Video Products Technical Bulletin 30-2002-168

DATE: **September 16, 2002**SUBJECT: **HOLES FOR ACCESSORY INSTALLATION
LOCATED INCORRECTLY**MODEL: ***BVM-D9H1E***
BVM-D9H1U

BVM-D9H1E *2,000,021–2,000,030*
 BVM-D9H1U 2,000,389–2,000,410

Figure 1

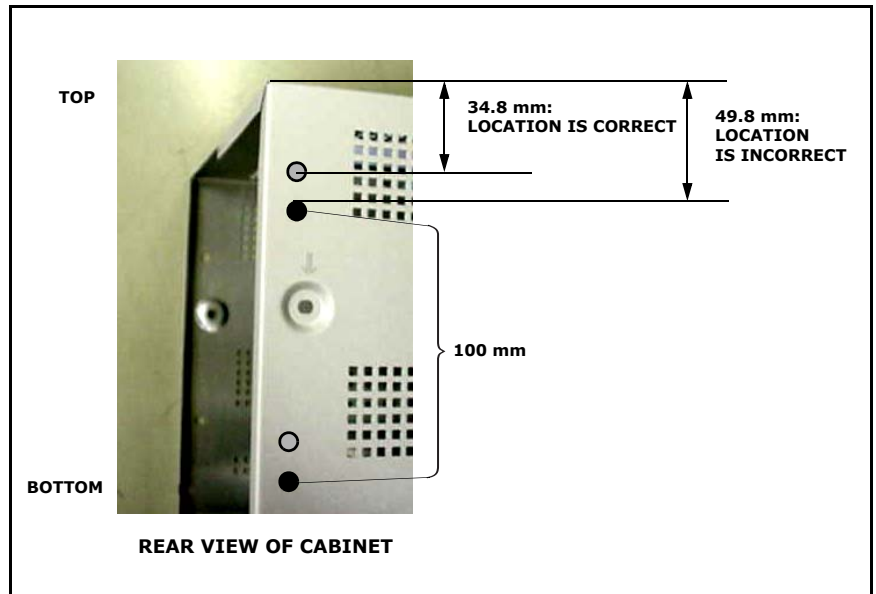
CONFIRMATION**(See Figure 1.)**

Measure the distance between the top of the cabinet and the center of the first hole.

If the distance is:

- 34.8 mm: Location of the holes is correct.
- 49.8 mm: Location of the holes is incorrect.

- The cell spacer (nut) can be seen through the hole when located incorrectly.
- There are four holes (5.5 mm) for installation of accessories.

Confirm the location of the holes. If the location is incorrect, perform the modification procedure.

Figure 2

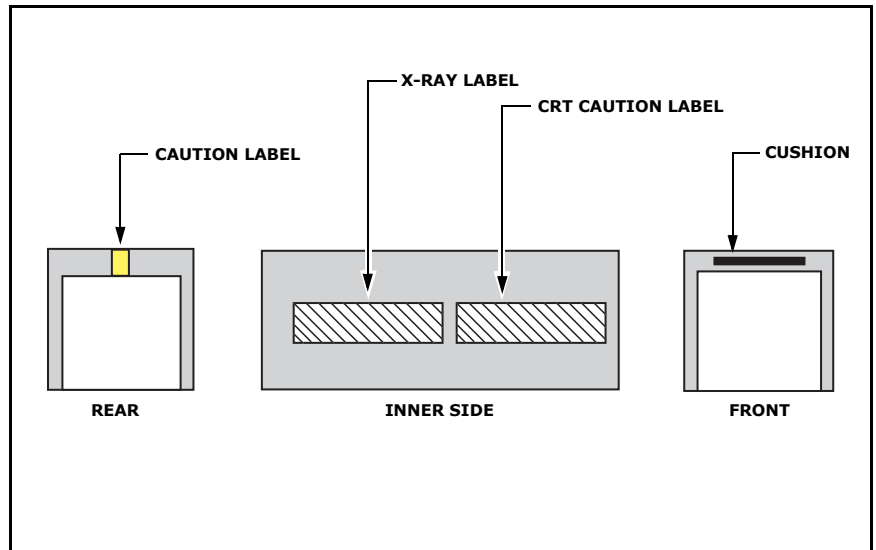
1. Replace the cabinet assembly with a new cabinet assembly.
2. Confirm that the following items are properly affixed to the cabinet assembly. (See Figure 2.)
 - Caution label (all units)
 - CRT caution label (units in US only)
 - X-ray label (units in US only)
 - Cushion (all units)
